Re: License No. SUB-908
Docket No. 040-07604

Subject: Supplemental Data and Information
NRC Request of April 23, 1993

SUBJECT: RESPONSE TO BP CHEMICAL'S REQUEST FOR ADDITIONAL
INFORMATION RELATED TO THE CAT-21 D&D PROJECT DATED 13
AUGUST 1993.

CATALYST PLANT PERIMETER SOIL GRID LAYOUT AND STATUS

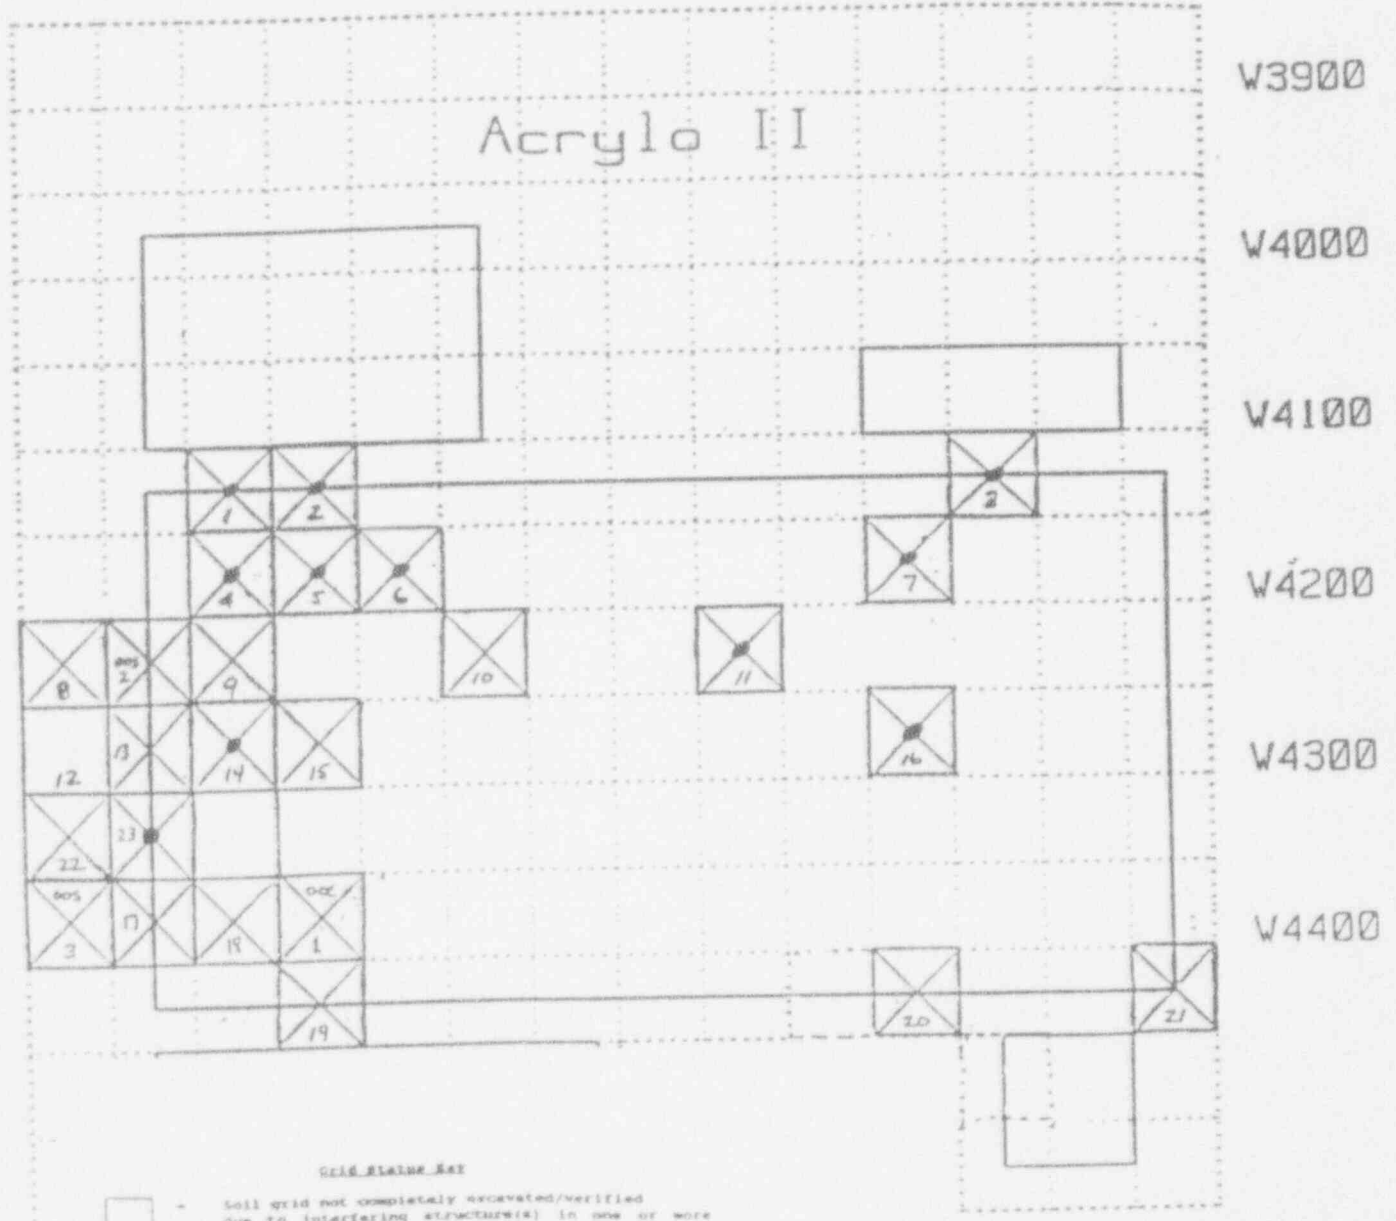
• NRC Comment: Bullet 5 Volume 3 of 3, Enclosure 8: Some figures provided in Enclosure 8 are incorrectly keyed to indicate where ORISE collected samples. It appears that BP Chemicals misinterpreted areas indicated as remediated on ORISE's figures to also mean soil samples were collected.

Figure: CATALYST PLANT PERIMETER SOIL GRID LAYOUT AND STATUS

Blocks 14 and 15

RUST Answer: Refer to enclosures 1,2, and 3 for corrected figures.

ACRYLO II SOIL GRID LAYOUT AND STATUS

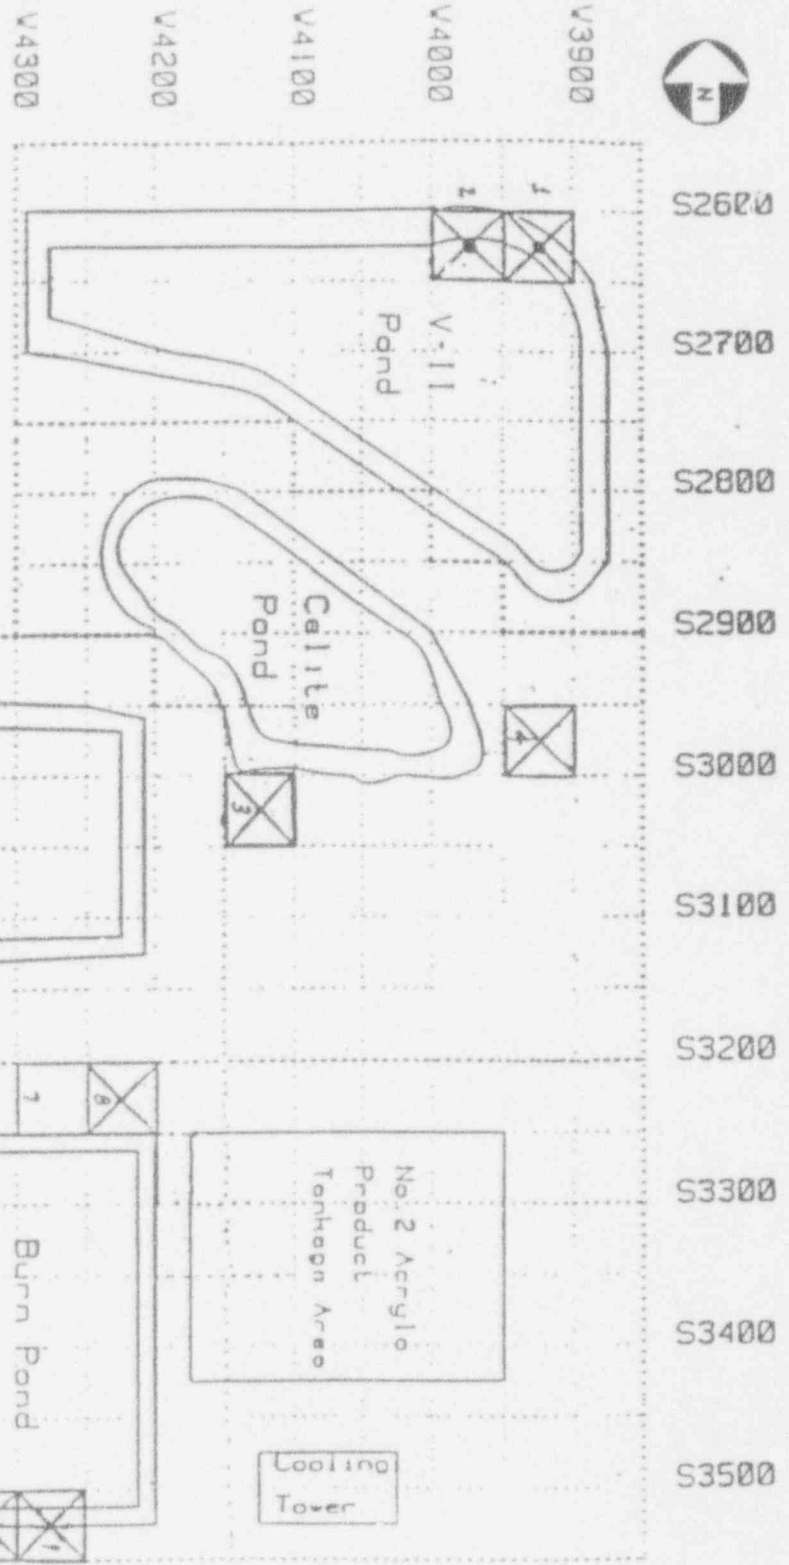
• NRC Comment: Bullet 6 Volume 3 of 3, Enclosure 8: Figure: ACRYLO II SOIL AND GRID LAYOUT AND STATUS, Grid Coordinate: S3982, W4218:

It is unclear whether BP Chemicals has addressed the location with elevated uranium concentrations levels which ORISE identified at this grid.

Figure: ACRYLO II SOIL GRID LAYOUT AND STATUS

Block 23
Grid coordinate: S3700, W4300

RUST Answer: Grid Coordinate, S3982, W4218, is identified on "BP Chemicals Decommissioning Project Soil Survey Data Sheet as W4250, S3950 and was addressed as indicated by enclosure 4.
